# JAMESON ACOUSTICS

| Our Ref   | 22015-TN-4-R0      |

## Waterhouse Gardens, Manchester Block C & D – Response to EHO Comments on PC18 & 19

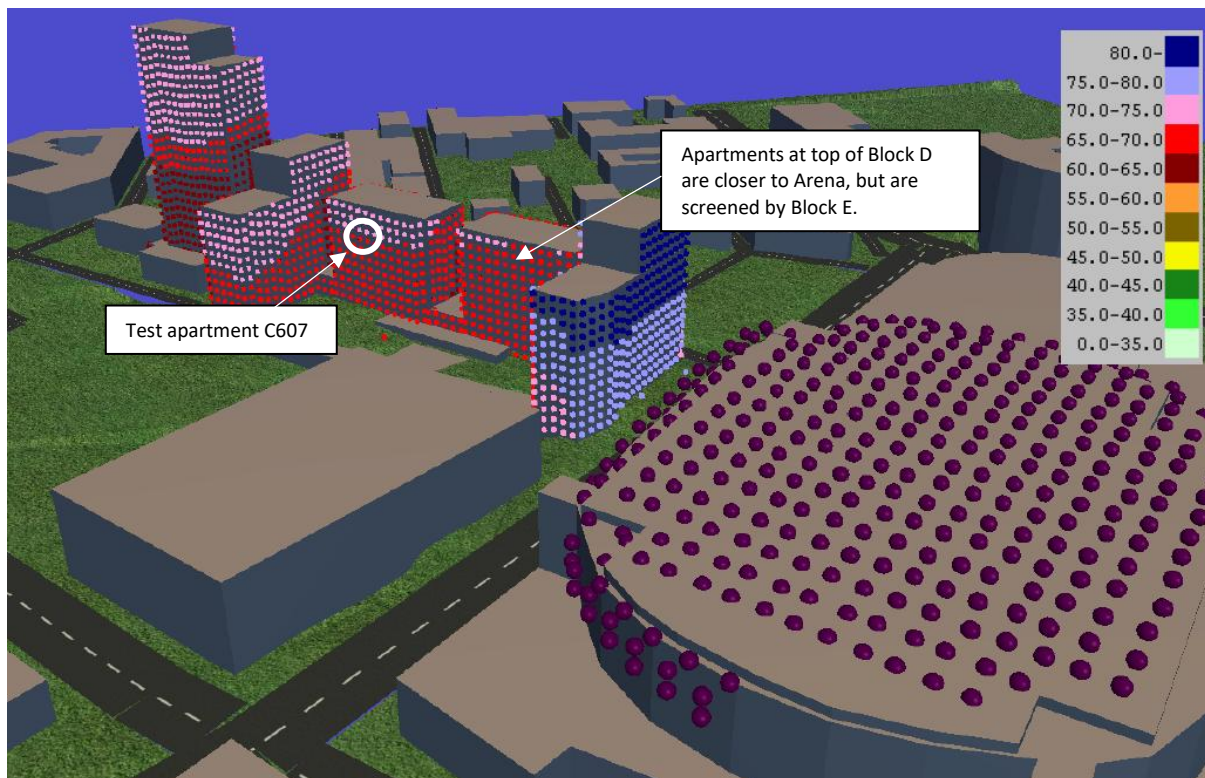
- 3. We can accept the assessment provided but only 4 units have been tested so far and we will require at least 10% of residential apartments to be tested for validation purposes. We will also require further comment with regard to the assessment during an event at the Arena as we will also need validation assessment of any apartments that over look the roof of the Arena. It is not clear if the apartments tested were of sufficient height or location to over look the Arena roof.***

- 4. Residential units for the remaining blocks (A, B, E and F ) will also require assessment and validation as this report only covers Blocks C&D***

Referring back to the continuous noise logging (environmental and event noise) survey for Block C & D, measurements to the rear (south facing) apartments were undertaken at Level 6 in apartment C607 (Block C) which was the highest available apartment for testing and overlooked the roof of the Arena roof. It represents the most exposed area of the rear elevation of both Blocks C & D to noise breakout from the Arena roof. Note, upper level apartments in Block D benefit from screening afforded by Block E, whereas these apartments in the top corner of Block C do not. See below image from the noise map to help clarify the position.

Based on the noise model above, you will also notice the eastern face of Block B (upper floors) is exposed to Arena noise breakout. Incident music levels are likely to be equivalent to those on the upper floors of Block C & D. Again, we will increase the concentration of noise logging to capture apartments in this area.
